**Product Change Notice**

Change for the Tape Sticking Type of the Reel.

CZRA4740Y series will be changed as below pictures:

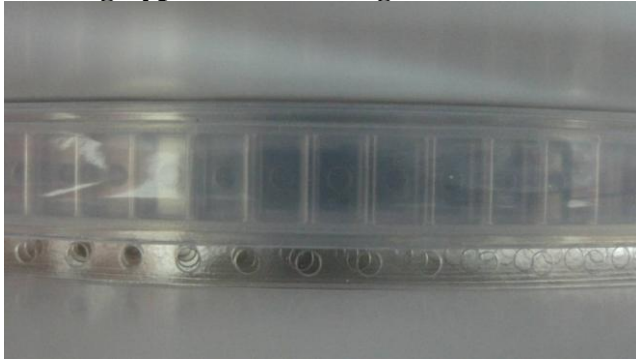
Before of change	After of change
<p><b>Sticking Type : Self-Sticking</b></p> 	<p><b>Sticking Type : Heat-Sealing</b></p>

1. Heat-Sealing tape sealing is better, without environmental impact.
